TO: Planning Commission Chair and Members

SUBMITTED BY: Peter Imhof, Planning and Environmental Review Director

SUBJECT: Appeal of Design Review Board (DRB) Preliminary and Final Approval for Parking Lot Lighting at the Church of Jesus Christ of Latter-day Saints; 478 Cambridge Drive; APN 069-560-031; Case Nos. 24-0032-DRB, 24-0052-ZC, 24-0003-APP, 24-0004-APP

Multiple errors on placement of photometrics and foot candles on submitted plans

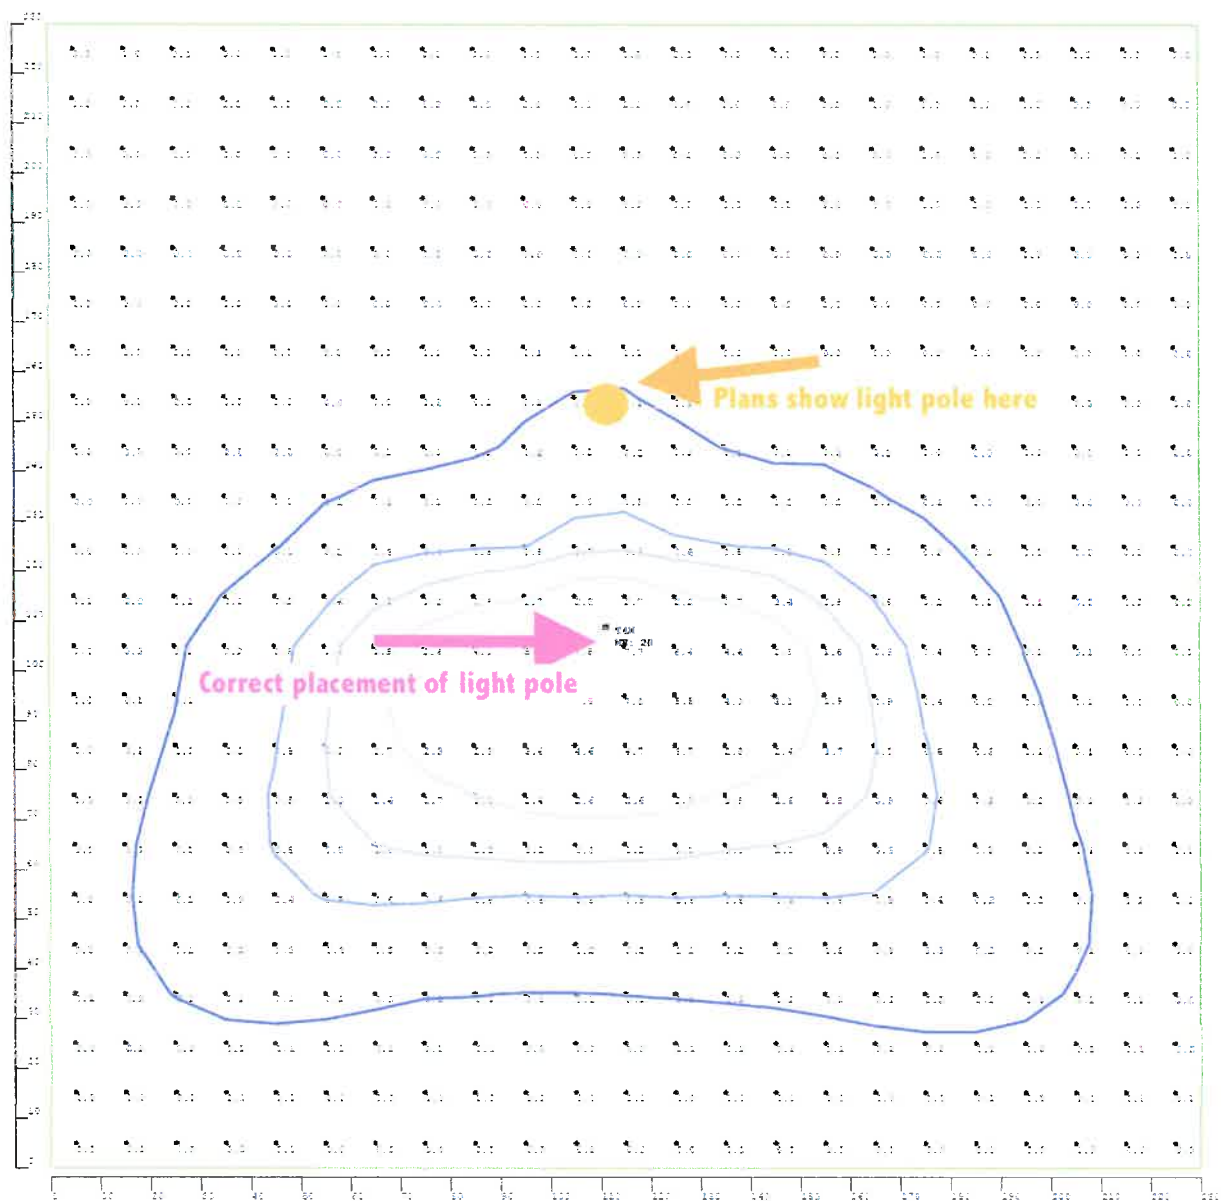
• The plans incorrectly located all the light patterns in all sections of the plans that show light patterns (pages 6, 8, and 9 of the plans). Particularly, the photometric study on page 9 of how the proposed flood lights will impact neighboring properties using foot candles is significantly incorrect. The applicant placed all the light patterns in the wrong place. On page 9, the light poles are noted by red circles with an arrow. The light manufacturer, Westgate, confirmed that the light pole location in the photometric study is nearer to the center of the shaded area, not at one end. If you look at the SE corner (closest to my house) on page 9, you will see the actual light pole in the photograph (in the planter) that shows up as a slight diagonal line next to the red-and-white North arrow. The placement of the pole light on the plans is incorrect, but more importantly, the photometric yellow shading should be nearly centered on that pole. In **Attachment A**, I capture a portion of the plans and have moved the yellow light shading closer to its proper location for this one corner (but all shading on the plans is incorrectly located per the light manufacturer).

- The photometric study used in the plans appears to be based on a 20-foot light, not a 14-foot light as proposed, therefore all the foot-candle measurements are likely too low. The foot candles will be significantly brighter because the bulb is not as high (using the inverse square law). I will endeavor to provide correct photometrics from the light manufacturer before the hearing.

- Also on page 9 of the plans, the applicant shows a black-and-white diagram of the photometrics in the right column below the schedule and above the statistics. That small notation near the center says "T4M MH:20" although it is illegible on the plans. That notation refers to the location of the lens in the photometric diagram. Please see **Attachment B** for an enlargement of this diagram that is legible. The light's lens is near the "7.7" foot-candle notation per the manufacturer's specifications, and you can see that the 7.7 notation on the plans is *not* where the applicant put the light pole (red dot). The light pole is supposed to be close to this 7.7 fc notation. The manufacturer confirmed that the light will be strongest for this downward-facing lens directly under the light, and weaker the further you go from the light source. See manufacturer's specifications as **Attachment C**.

Section of page 9 of plans as submitted; photometrics (yellow shading) are incorrect:

Photometrics (yellow shading) should be radiating from near the center of the light pole (per the light manufacturer), where I drew in the stars, but the applicant put the photometric shading in the wrong place. I moved one to its approximate correct location in the SE corner as an example here;

DRB members spent a lot of time reviewing the plans and asking questions. While there is a typo on the plans that says the lights will be on from “dawn to dusk,” this error has been corrected by the applicant. The plans now state the lights will be on from “dusk to dawn” and that the lighting will not be on during daylight hours. The DRB did consider photocells for the lights and placed a Condition of Approval that the light controls be photocell-controlled, so that the lights will not be on during daylight hours, will have an on-and-off switch with a timer override, and will include digital controls. Additionally, with the lights on motion sensors, the lights will be activated in the evenings only when motion is present near the affected light poles.

The plans contained a typo, which unfortunately was missed by staff. The plans state that the lighting will be on "from dawn to dusk," but the typo has been corrected to say from "dusk to dawn" on the plans.

Attachment C for #1 above:

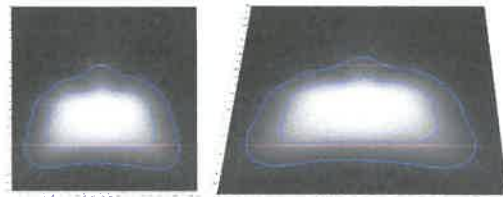
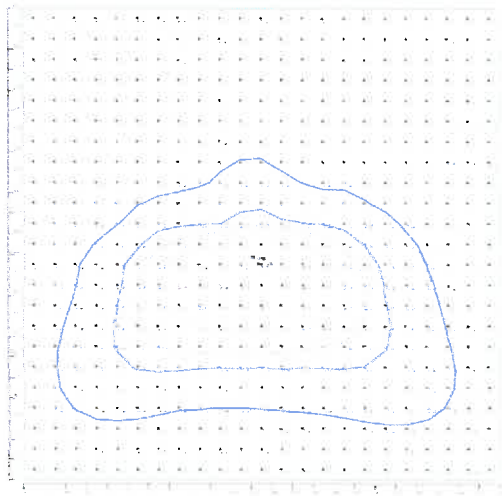
These specifications are just an example and show a different height pole, but do show the correct location of the light pole within the photometric diagram. See Attachment B for an enlargement of the diagram. Project proposes T4M lens.

PROPOSED SITE LIGHTING PLAN

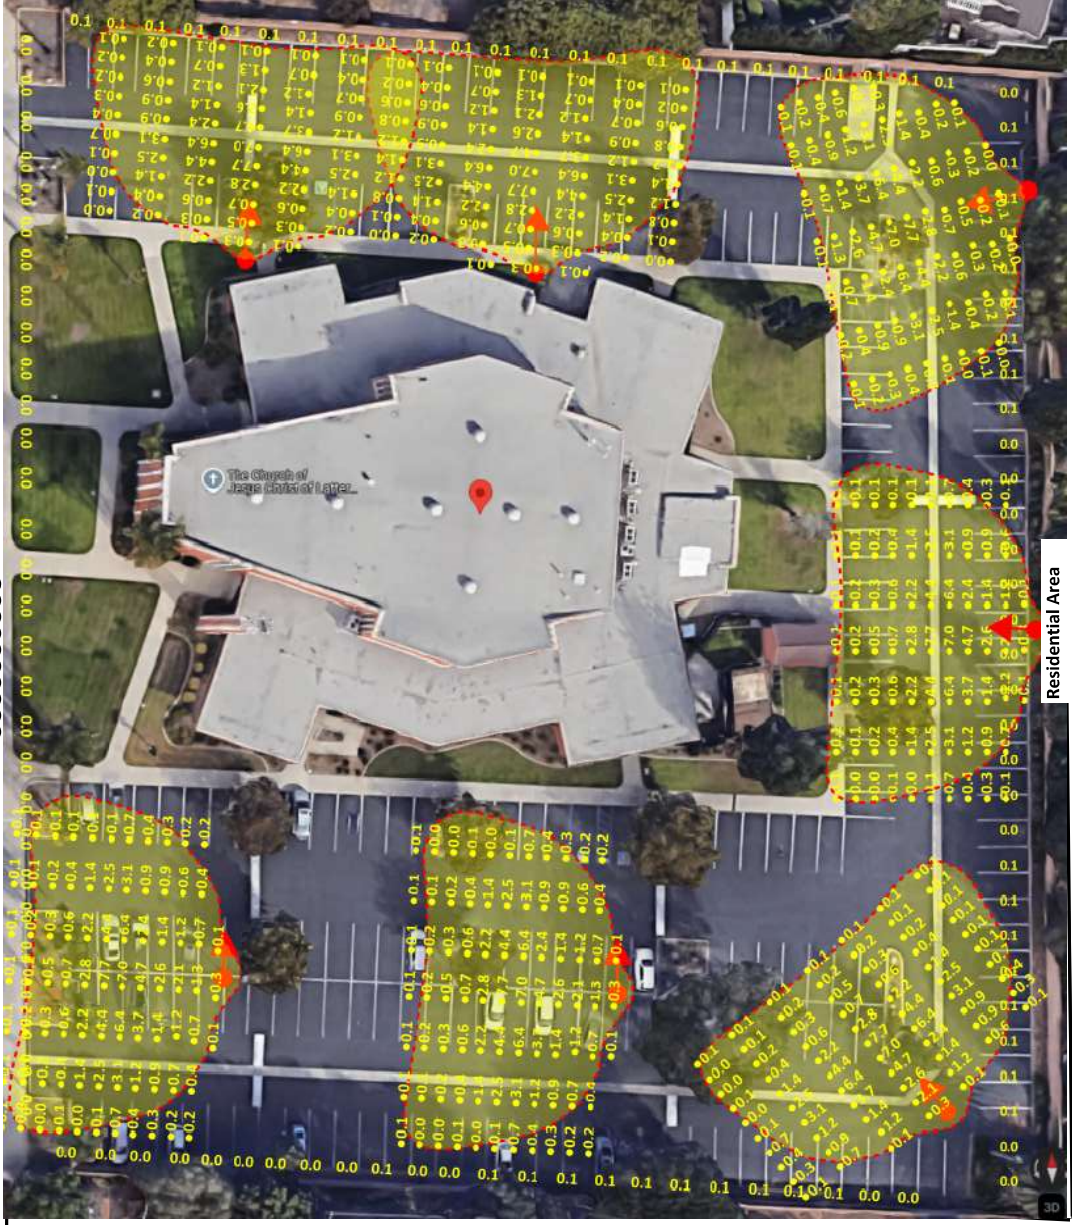
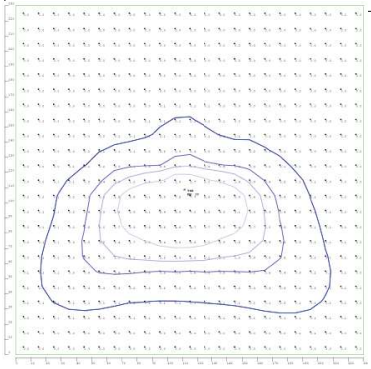
- The BUG rating for light fixtures can be used to determine glare. This rating for the proposed lights is B3-U0-G3 as shown on page 10 of the plans.

The uplight rating on these lights is 0 (meaning no light goes upward past the horizontal plane of the light), but the backlight and glare are definitely too high and do not meet zoning requirements. The zoning requirements provide for "full cutoff." A BUG rating for backlight and glare of 3 will likely not meet the full-cutoff or glare requirements.

The plans were prepared by a drafter with Excel Construction, Inc. (Applicant), whose company holds an electrical license. A licensed contractor would be responsible for construction of the lighting and the plans would need to meet Building Code standards for electrical work. The plans show that the lights meet this requirement and the light level at the property lines will not exceed 0.1 foot-candles. Further, this section of the ordinance states that lights must be turned off during daylight hours and during any hours when the structure is not in use and specifies outdoor lighting requirements for motion sensors, which the proposed project will meet. The proposed lights will be on a motion sensor, so they will only be activated as needed by visitors to the Community Assembly.

The appellant has emphasized that the City's ordinance requires the minimum lighting necessary. The applicant has agreed to the Conditions of Approval placed on the project by the DRB to include timers, motion detection, shrouds and has clarified on the plans that lighting will only be on from dusk to dawn.

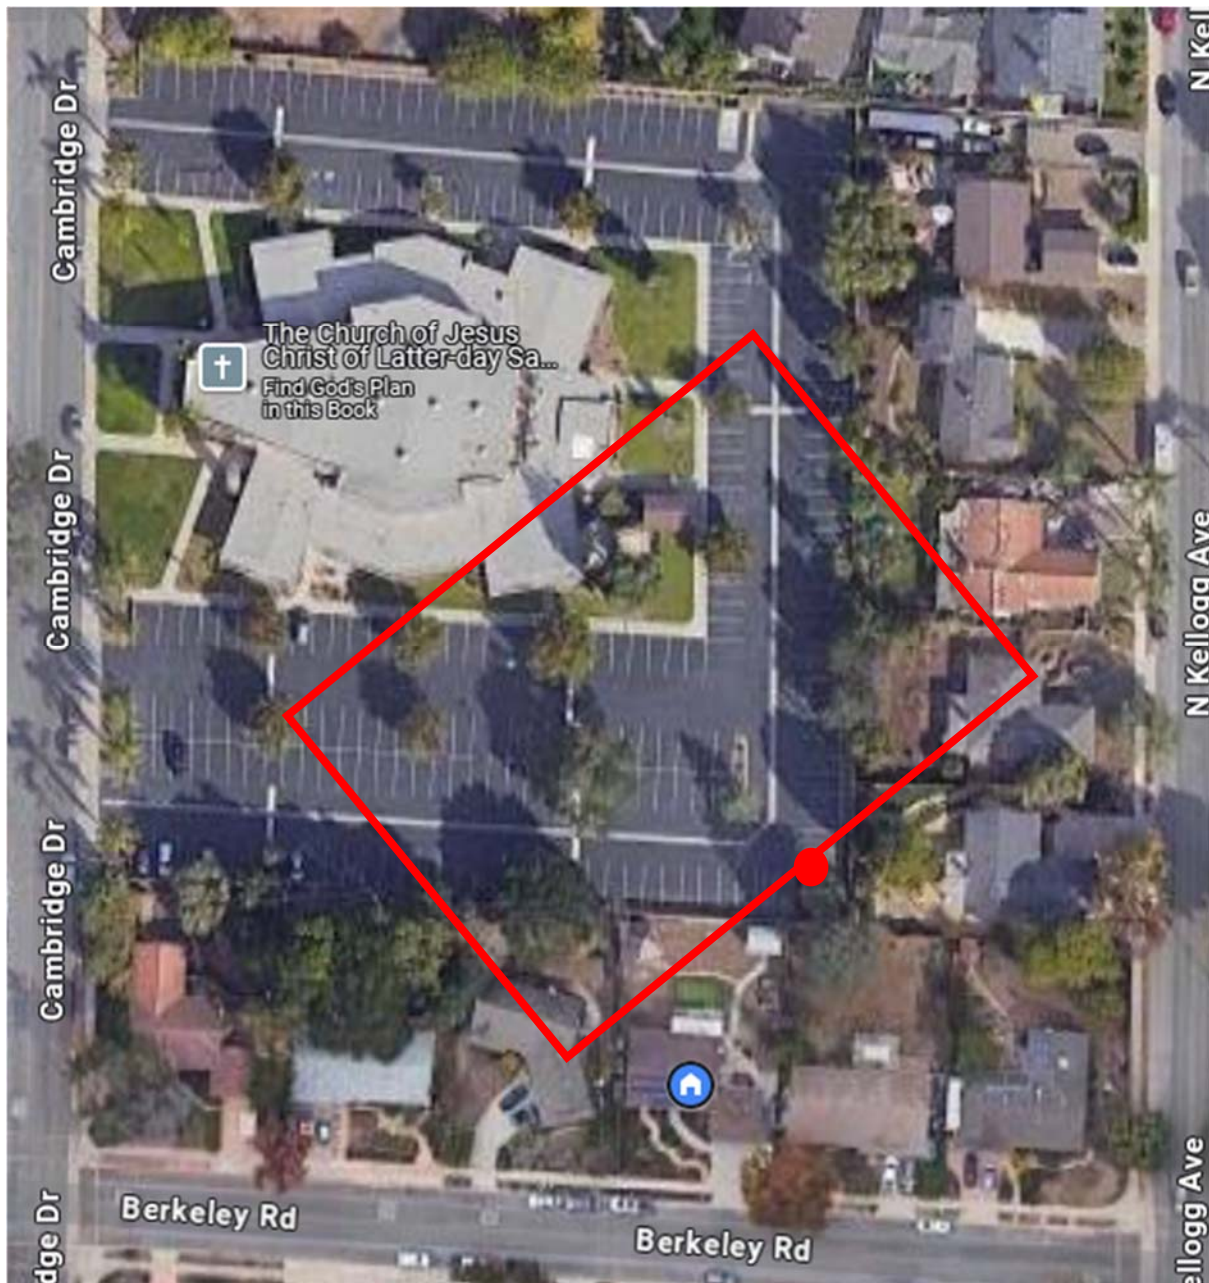
Continuing to comment on the inaccuracy in the drawing on page 6, the “approximate existing light distribution pattern” is just not accurate at all. This **one** light in the SE corner of the church property fully illuminates the church building approximate 150’ away and as indicated in my “approximation” below. Due to the angle of the light placement, it bathes many of the adjacent residential homes in “stadium” Lighting, it is literally daylight from dusk till dawn when this light is on.

To put in perspective the specifications listed for EACH light is 29,000 lumens (see page 9 of the proposal). A typical residential streetlight is about 5,000 lumens (<https://www.heisolar.com/how-many-lumens-do-i-need-for-outdoor-lighting/>). Why do the proposed lights need to be almost 6 times brighter than a residential street light? The fact is they don’t need to be, there is a reason residential

Photo 1:

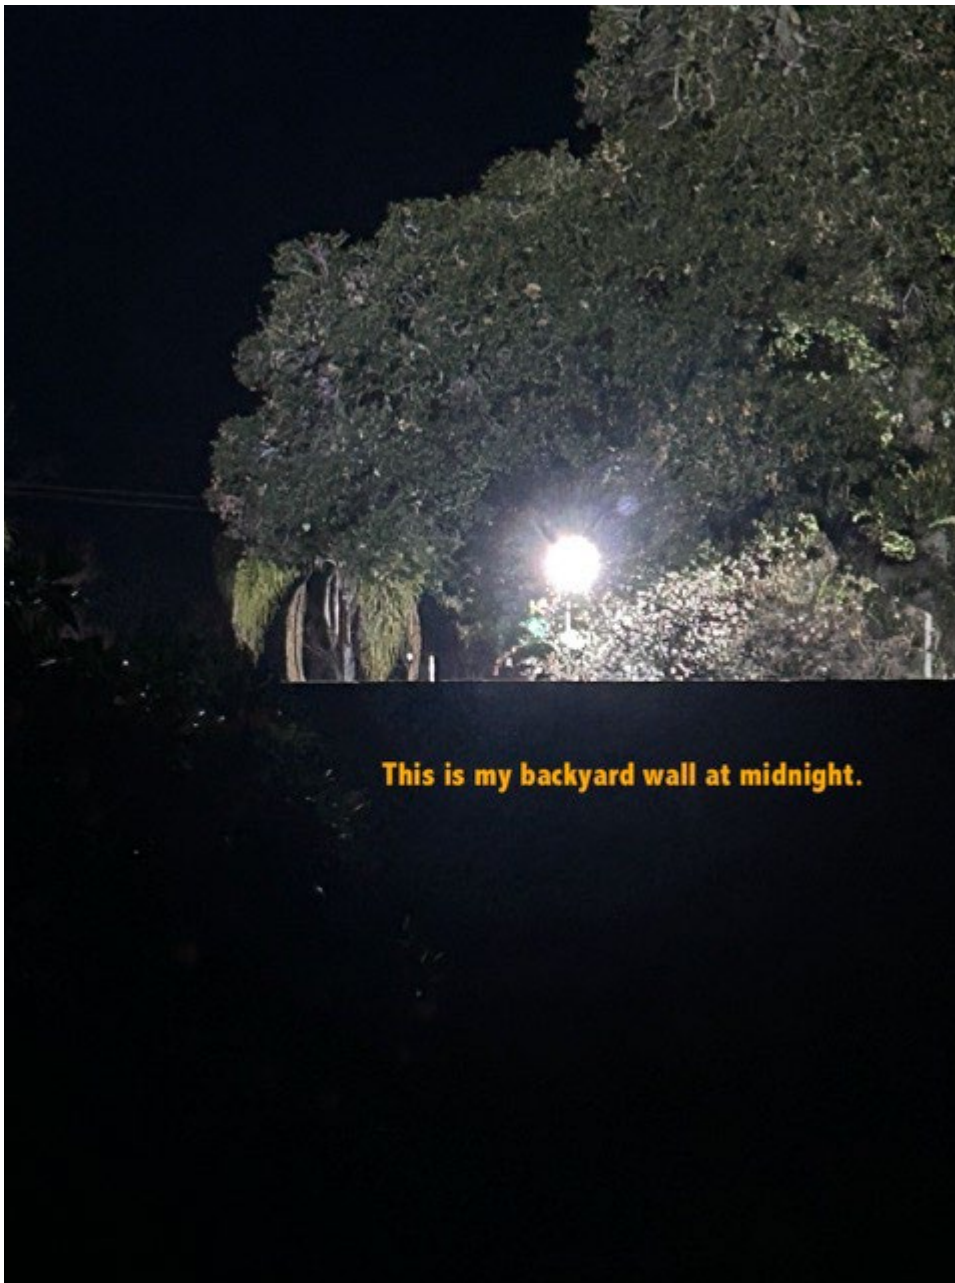
A 14' light pole will shine directly into my backyard! There is NO need for a light in this back corner of the parking lot. A 2 or 3" shroud will not help!

Photo 2: A zoomed in shot of the light — this is the light that is NOT next to my yard, but mid way into the parking lot. This is how a 14' light will look in my yard!
